**ON-SITE SEWAGE DISPOSAL SYSTEM
 HOWARD COUNTY HEALTH DEPARTMENT
 BUREAU OF ENVIRONMENTAL HEALTH**

05-372313

ADDRESS: 7013 MINK HOLLOW ROAD PROPERTY OWNER: HYNES

LOCATION DRAWING
 7013 Mink Hollow Road
 5th election district
 HOWARD COUNTY, MARYLAND

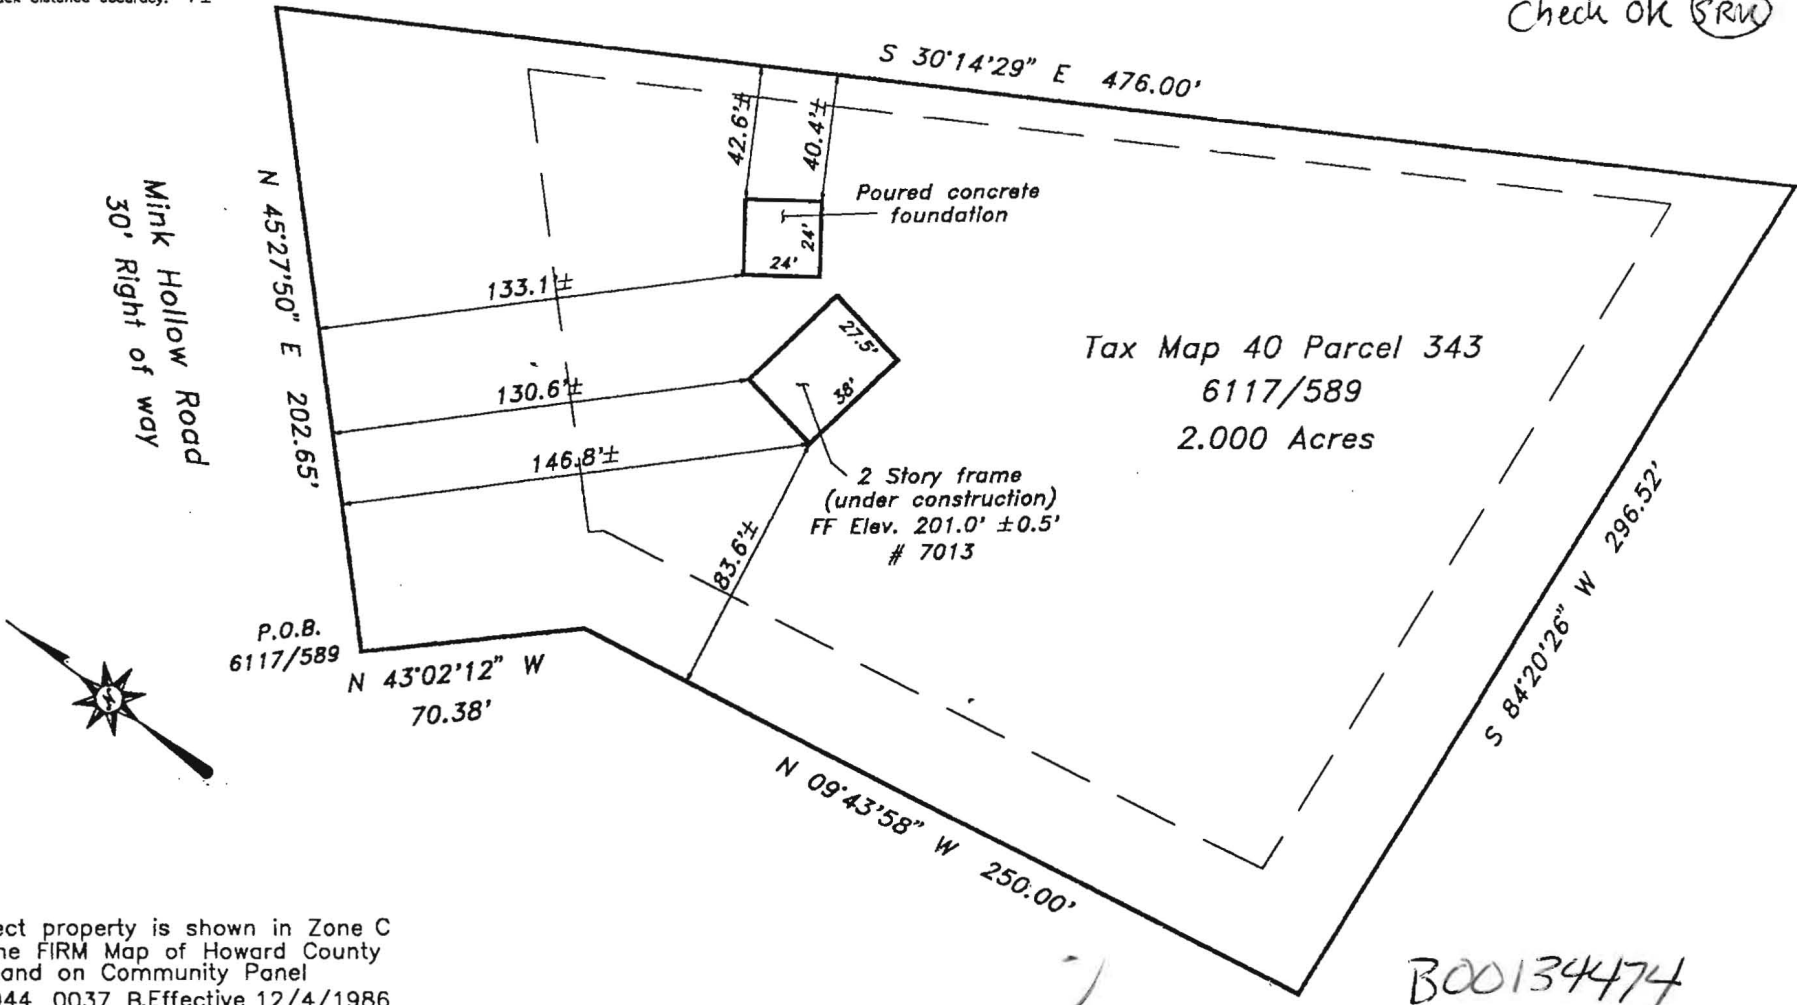
PRE-CONSTRUCTION Place S.T. @ 50'-53', D.B. @ 60'; Move 25' uphill
 3-80' trenches. Cut 20' from SDA closest to the house. 12" CTC
 INSTALLATION 20' may be added later if necessary due to acceptable
 soils. Noted: Topsoil cut where S.T. originally proposed. Inlet now 3'
 and bottom @ 5'. Run trenches on contour (KN) OK to cover all
 work. Need house conn. WPI - house conn ✓; pitless OK; 1 1/2" conduit
 grant OK 6/5/02
 6/10/02 House conn complete (SO)

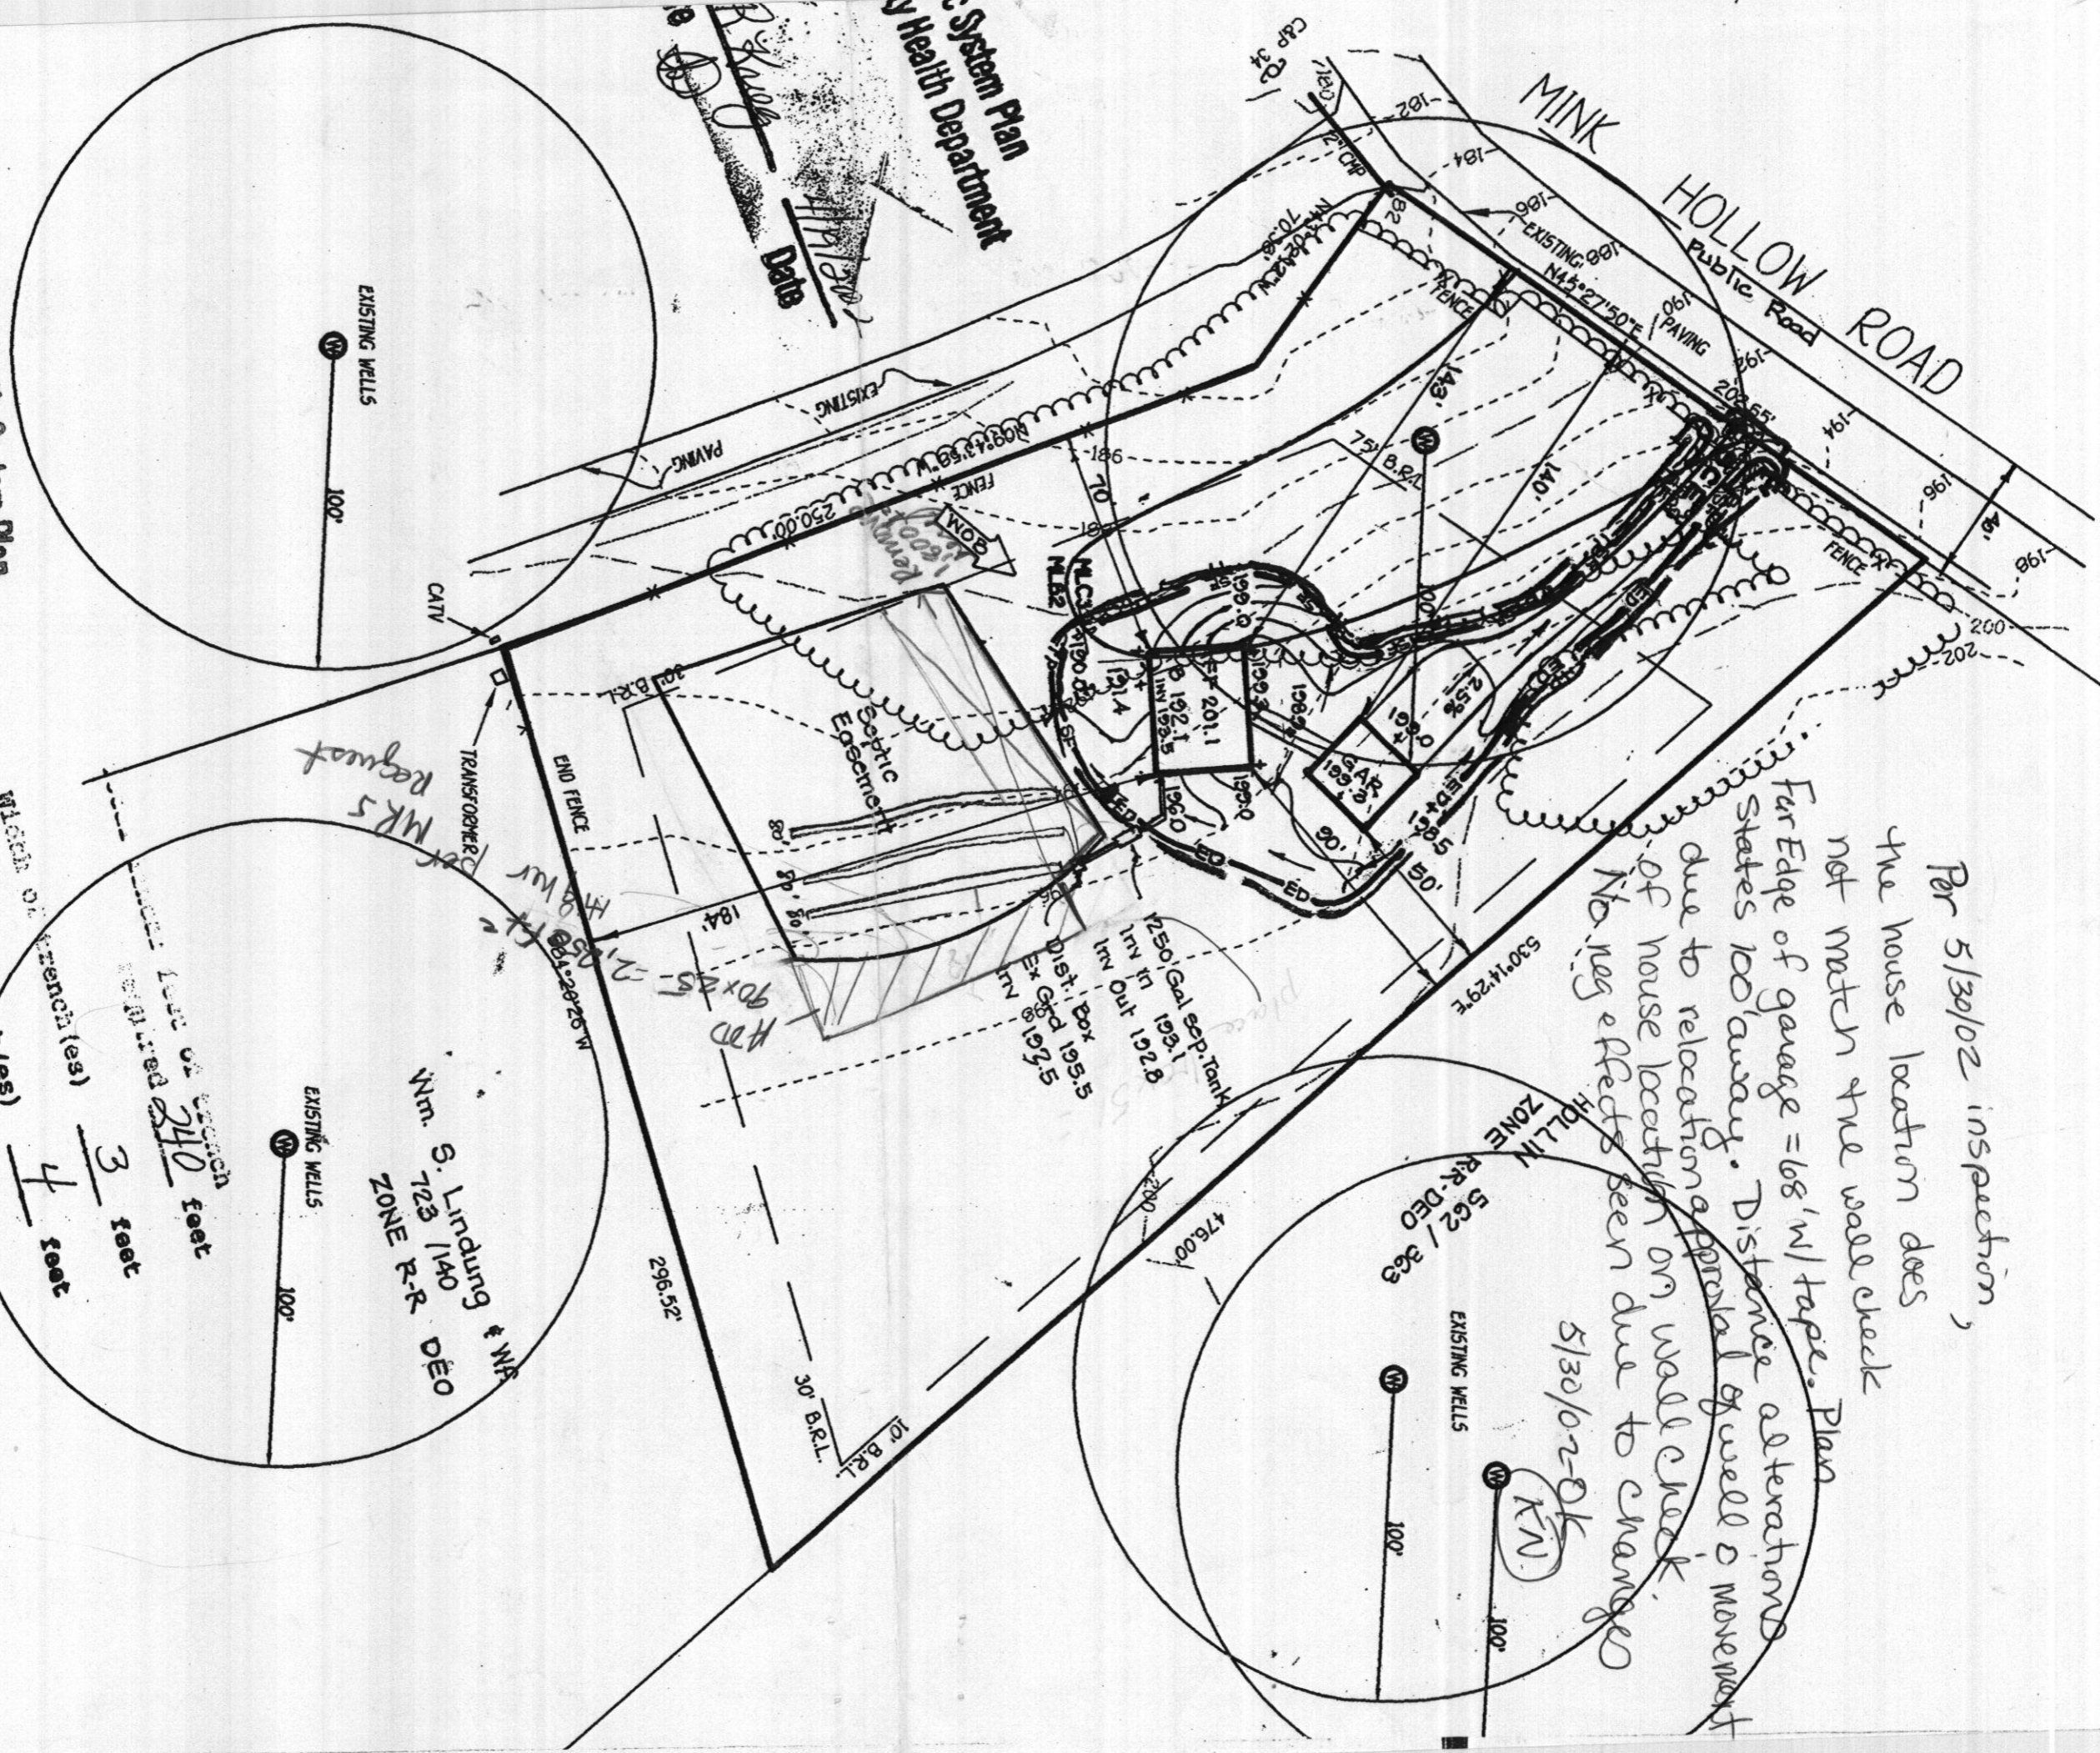
Per 5/30/02 inspection, the house location does not match the wall check. Far Edge of garage = 68' W/ tape. Plan states 100' away. Distance alterations due to relocation a proposal of well movement of house location on wall check. No neg effects seen due to changes.

5/30/02-OK
 (KN)
